Contract #: 04-0120F4Cty: SF/ALA Rte: 80 PM: 13.2/13.9File #: 69.25B**QUALITY ASSURANCE -- NON-CONFORMANCE REPORT****Location:** Changxing Island, Shanghai, P.R. China**Report No:** NCR-000890**Prime Contractor:** American Bridge/Fluor Enterprises, a JV**Date:** 11-Nov-2010**Submitting Contractor:** Zhenhua Port Machinery Company, Ltd (ZPMC), Changxing Island**NCR #:** ZPMC-0852**Type of problem:**

**Reference Description:** Remove 119m Backfill plate weld without Engineer's approval**Description of Non-Conformance:**

**Job Name:** SAS Superstructure

**Subject:** NCR No. ZPMC-0852

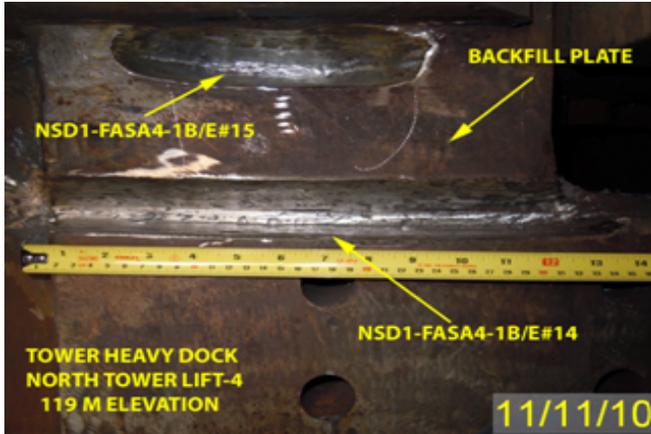
During the Caltrans Quality Assurance (QA) in-process observation on Lift-4 tower shafts, this QA Inspector discovered the following issues:

-After Ultrasonic Testing (UT) rejection of backfill plate welds by ZPMC quality control personnel, ZPMC fabrication personnel removed a total four (4) Non-SPCM welds in North, South and East shafts respectively without notifying the Engineer .

- The Non-SPCM welds are Butt-Joint Complete Joint Penetration (CJP) welds joining backfill plate to doubler plate.

- These welds measured to be approximately 330 mm in length.

- Backfill plate thickness is 50 mm.

1)North Shaft - NSD1-FASA4-1B/E#14

2)North Shaft - NSD1-FASA4-1B/E#17

3)East Shaft - ESD1-FASA4-2B/E#26

4)East Shaft - ESD1-FASA4-2B/E#27

- The whole length of the Non-SPCM welds has been removed.

Contractor to repair welds and perform NDT to prove welds are acceptable. Contractor will issue an internal NCR and discipline personnel involved to avoid future occurrences.

Contractor performed and submitted the NDT reports to prove the welds are acceptable. Contractor also issued an internal NCR to make personnel aware that prior notification to the Engineer is required prior removing any improperly fitted and welded members are cut apart.

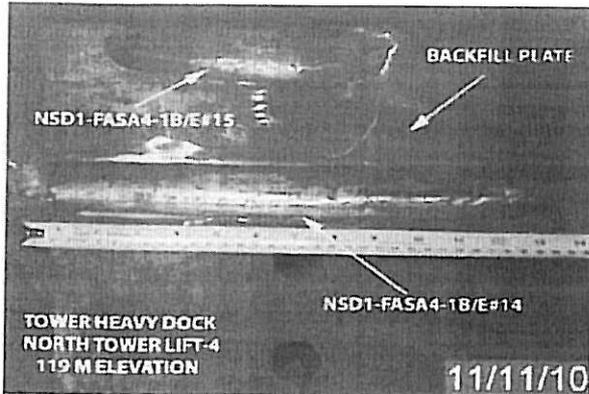
During the Caltrans Quality Assurance (QA) in-process observation on Lift-4 tower shafts, this QA Inspector discovered the following issues:

-After Ultrasonic Testing (UT) rejection of backfill plate welds by ZPMC quality control personnel, ZPMC fabrication personnel removed a total four (4) Non-SPCM welds in North, South and East shafts respectively without notifying the Engineer .

- The Non-SPCM welds are Butt-Joint Complete Joint Penetration (CJP) welds joining backfill plate to doubler plate.

- These welds measured to be approximately 330 mm in length.

- Backfill plate thickness is 50 mm.

1)North Shaft - NSD1-FASA4-1B/E#14

2)North Shaft - NSD1-FASA4-1B/E#17

3)East Shaft - ESD1-FASA4-2B/E#26

4)East Shaft - ESD1-FASA4-2B/E#27

- The whole length of the Non-SPCM welds has been removed.

WELD NUMBER: ESD1-FASA4-2B/E-27

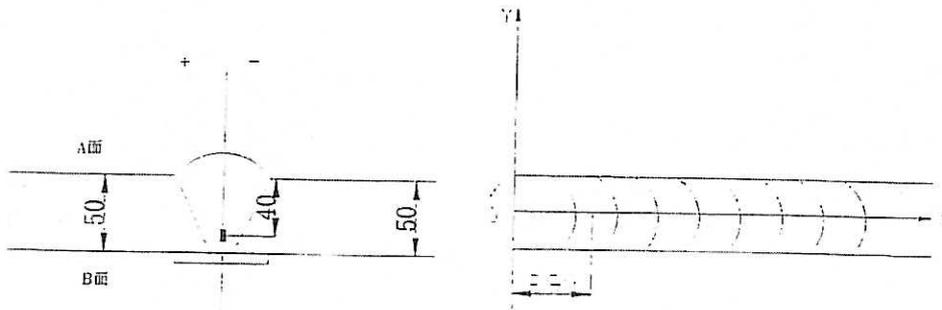
Weld No. 焊缝编号为: ESD1-FASA4-2B/E-27Welder ID No. (焊工编号): 046769Position:(位置) : 1G检验员 (Inspector) : Dai Gengsheng日期(Date) : 2010.11.10

1. Did not clear the weld pass completely in time.

1. Prepare the joint according to the approved WPS.
2. Grind or gouge the repair area to a smooth finish according to the approved repair WPS.
3. Remove all defects by grinding to ensure all defects are completely removed if defects still exist.
4. Preheat and weld according to the approved WPS.
5. Grind the weld flush after welding.
6. Perform NDT of the repair area.

WELD NUMBER: ESD1-FASA4-2B/E-26

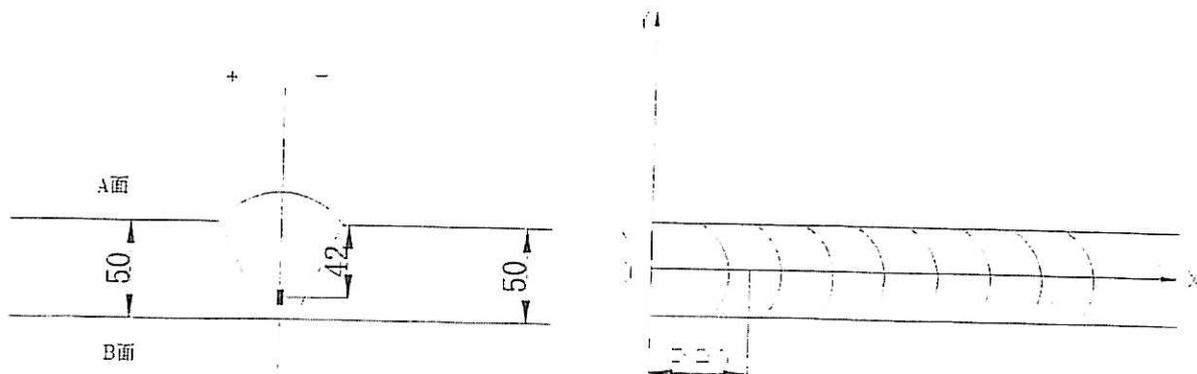
Weld No. 焊缝编号为: ESD1-FASA4-2B/E-26Welder ID No. (焊工编号): 046769Position:(位置) : 1G检验员 (Inspector) : Dai Gengsheng日期(Date) : 2010.11.10

1. Did not clear the weld pass completely in time.

1. Prepare the joint according to the approved WPS.
2. Grind or gouge the repair area to a smooth finish according to the approved repair WPS.
3. Remove all defects by grinding to ensure all defects are completely removed if defects still exist.
4. Preheat and weld according to the approved WPS.
5. Grind the weld flush after welding.
6. Perform NDT of the repair area.

WELD NUMBER: NSD1-FASA4-1B/E-17

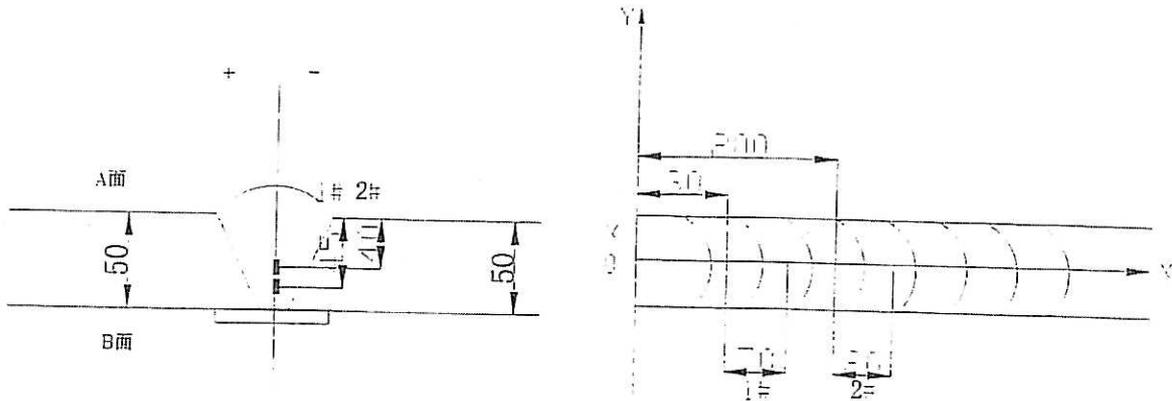
Weld No. 焊缝编号为： NSD1-FASA4-1B/E-17

1. 焊道未及时处理干净。
1. Did not clear the weld pass completely in time.

1. 准备一个正确的接头形式, 具体参见返修的WPS;
  2. 按照焊接返修工艺规程 (WPS) 打磨或碳刨缺陷区域至光滑;
  3. 如果仍发现有缺陷, 通过打磨的方法去除所有缺陷以确认缺陷完全被消除;
  4. 根据批准的焊接返修工艺规程 (WPS) 进行预热及焊接;
  5. 将焊接区域打磨至与母材平齐;
  6. 对返修区域作NDT检测。
- 
1. Prepare the joint according to the approved WPS.
  2. Grind or gouge the repair area to a smooth finish according to the approved repair WPS.
  3. Remove all defects by grinding to ensure all defects are completely removed if defects still exist.
  4. Preheat and weld according to the approved WPS.
  5. Grind the weld flush after welding.
  6. Perform NDT of the repair area.

WELD NUMBER: NSD1-FASA4-1B/E-14

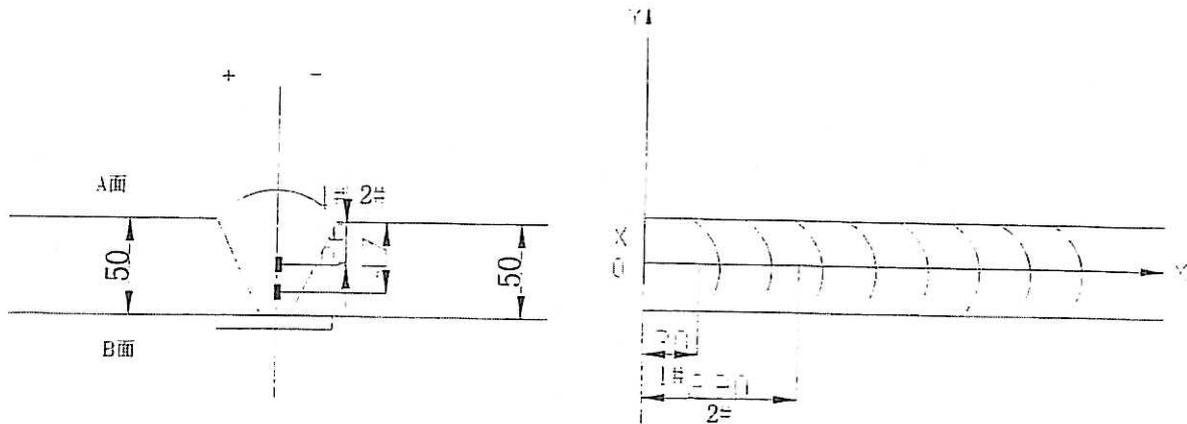
Weld No. 焊缝编号为: NSD1-FASA4-1B/E-14Welder ID No. (焊工编号): 040582Position:(位置) : 2G*Lin Jian*检验员 (Inspector) : Lin Jian日期(Date) : 2010.11.10

1. Did not clear the weld pass completely in time.

1. Prepare the joint according to the approved WPS.
2. Grind or gouge the repair area to a smooth finish according to the approved repair WPS.
3. Remove all defects by grinding to ensure all defects are completely removed if defects still exist.
4. Preheat and weld according to the approved WPS.
5. Grind the weld flush after welding.
6. Perform NDT of the repair area.

WELD NUMBER: ESD1-FASA4-2B/E-27

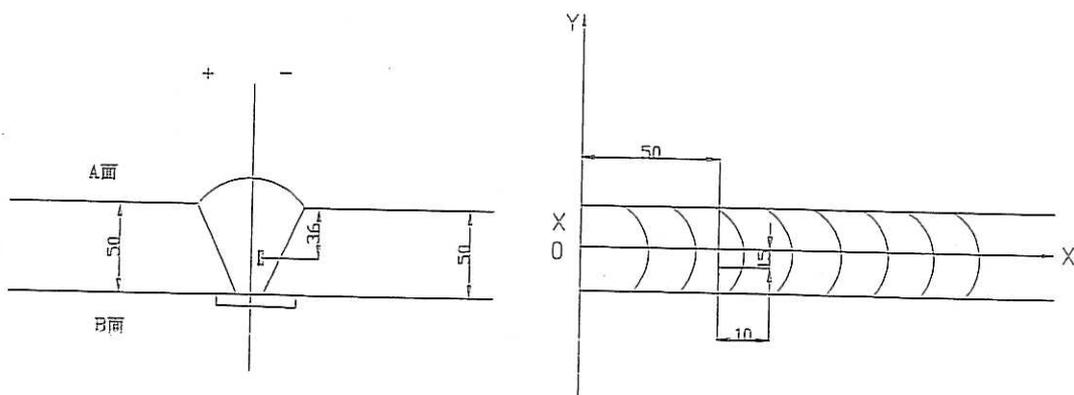
Weld No. 焊缝编号为: ESD1-FASA4-2B/E-27

1. Did not clear the weld pass completely in time.

1. Prepare the joint according to the approved WPS.
2. Grind or gouge the repair area to a smooth finish according to the approved repair WPS.
3. Remove all defects by grinding to ensure all defects are completely removed if defects still exist.
4. Preheat and weld according to the approved WPS.
5. Grind the weld flush after welding.
6. Perform NDT of the repair area.

WELD NUMBER: ESD1-FASA4-2B/E-26

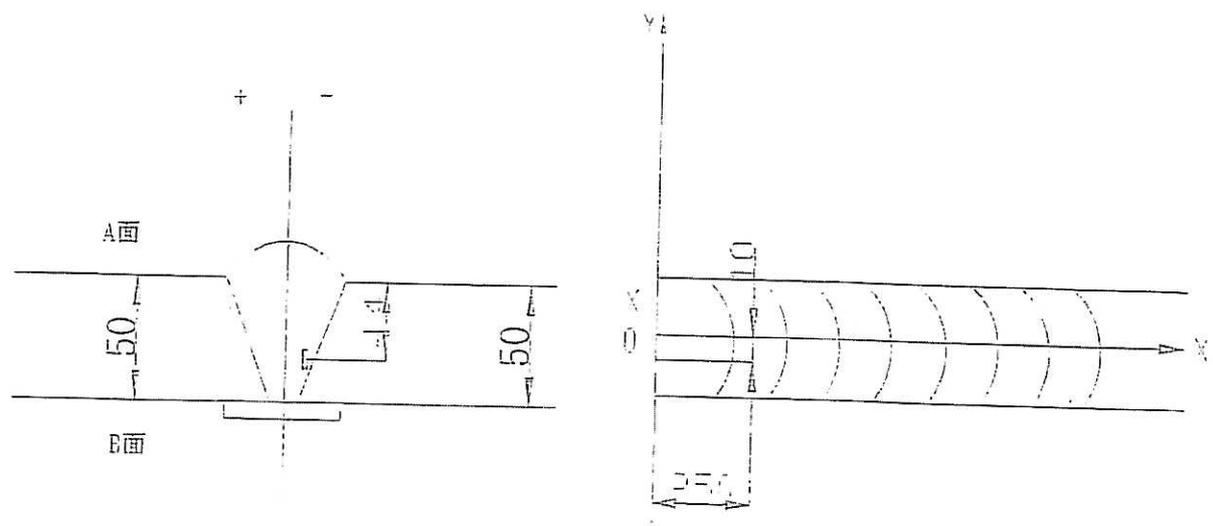
超过二次以上UT缺陷返修  
over two times repair

1. The weld defect location may not have been properly identified prior to grinding, i.e. the X and Y location was incorrect or the excavation was not centered on the defect, therefore the excavation did not encompass the whole defect.
1. 打磨前缺陷的位置没有标识清楚, 例如: XY的位置标的不正确, 或者没有将缺陷完全清除, 因此没有清楚所有的缺陷。

1. QC /CWI shall monitor and direct all gouging, grinding and welding during the repair procedure.
  2. Remove defects by gouging and /or grinding. If gouging is used, preheat the repair area to a minimum temperature of 65°C.

3. Prepare excavation according to the approved repair WPS.
  4. Grind the repair area to a smooth and shiny surface.
  5. Verify that no defects are present by VT and MT prior to welding.

6. Clean excavation of all loose debris and MT powder.
  7. Weld according to the approved WPS.
  8. Preheat and maintain interpass temperature control in accordance to the approved WPS.

9. QC shall ensure all slag has been removed prior to the deposition of the next pass.
  10. Blend the weld repaired areas into the adjacent weld or base metal by grinding.

11. Perform VT, MT and UT inspection to the repaired areas.
- 
1. QC 和 CWI 应当监督和指导所有碳刨、打磨和焊接工作;
  2. 使用碳刨和打磨方式去除缺陷, 如果使用碳刨方式, 则在碳刨前须将返修区域预热到 65° C;
  3. 根据返修 WPS 准备合适的刨槽;
